# UNITED STATES PATENT AND TRADEMARK OFFICE

This is the first office action for application number 10/735,529, Support Apparatus or Accessory for Ladder, filed on December 12, 2003.

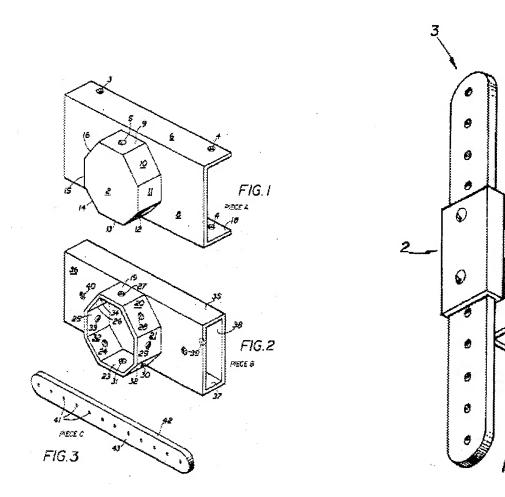
Claims 1-8, 10, 14, 15 and 21-24 are rejected under 35 U.S.C. 102(b) as being anticipated by U.S. Patent number 4,284,172 to Cohen.

Cohen '172 discloses a support apparatus (above) including a body (35-38, 42, 43), a primary attachment member (19, 20, 21, etc) connected to the body/adjustable length body, a secondary attachment member (6, 8, 9, 10, 11, etc.) secured to a side rail of a ladder, and locking means (bolt, see column 2, lines 25-37), wherein the body comprises a fixed component (35-38) to which the primary attachment member is connected and a movable component (42,43) capable of moving relative to the fixed component, wherein the fixed component comprises guiding means (within 35-38) in the form of a channel/housing/elongate continuous enclosed hollow tube, wherein the movable component is an inner member capable of telescopic movement relative to the housing, wherein the movable component is securable at a desired position relative to the fixed member by securing means comprising a securing pin (column 2, line 46) located on the fixed component (when attachment members are engaged) and a mating aperture (41) located on the movable component, wherein the securing pin when inserted into the mating aperture secures the movable component relative to the fixed component, wherein the primary and secondary attachment members engage in a male-female interaction, wherein the primary attachment member is a socket and the secondary attachment member is a peg.

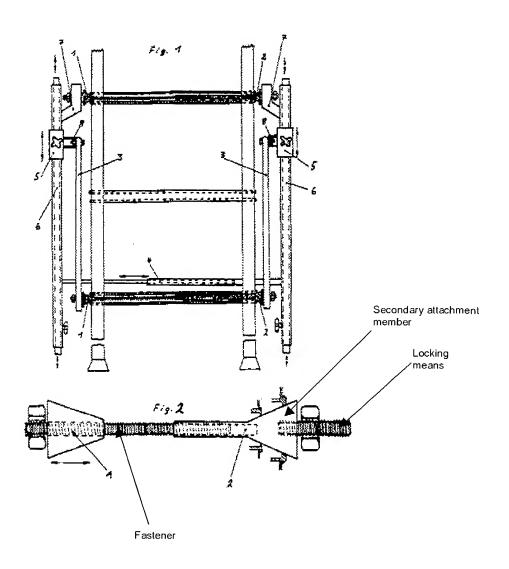
Claims 1 and 10-13 are rejected under 35 U.S.C. 102(b) as being anticipated by U.S. Patent number 6,382,353 to Laug.

Laug '353 discloses a support apparatus (figures 1,2) including a body (5,6), a primary attachment member (7) connected to the body/adjustable length body, a secondary attachment member (above) secured to a side rail of a ladder, and locking means (above), wherein the secondary attachment member is secured by a fastener (above) that is adapted to extend at least through the side rail of the ladder, wherein the fastener is a rod adapted to traverse the ladder from one side rail to another side rail, wherein the rod is adapted to be located within an adjacent rung of the ladder.
